PLAN 'A' 29/8/11

SOH – EASTERN SEA WALL Proposed Amendments to Stormwater Outlets 27.06.11

Approved Section 75W Modification Application

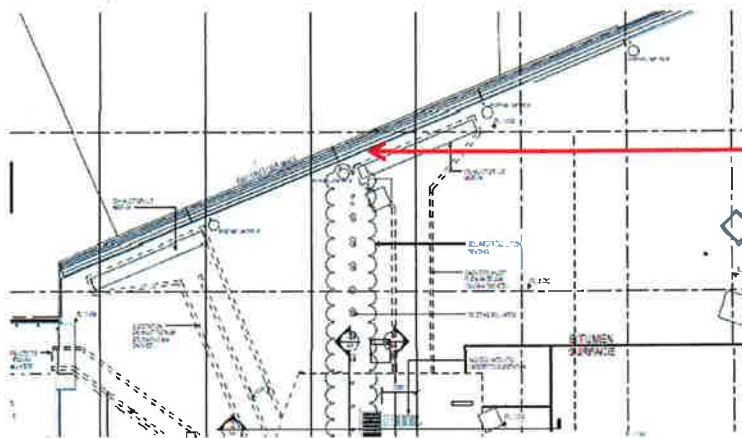
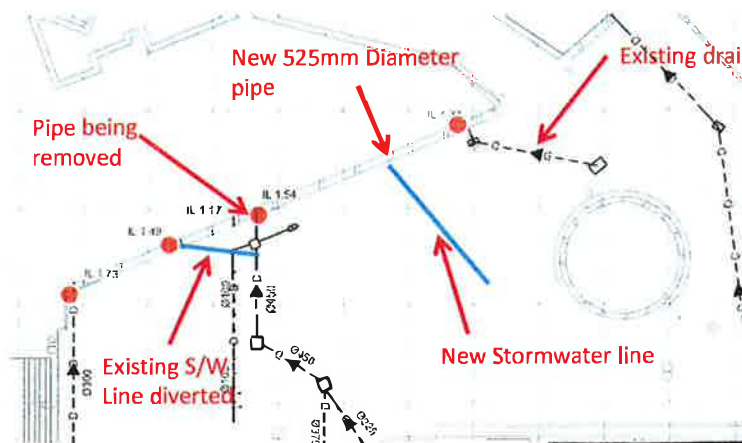
New plenums under the asphalt paving disrupts an existing stormwater outlet in this area. Proposed to remove; patch and replace with a new outlet as indicated below.
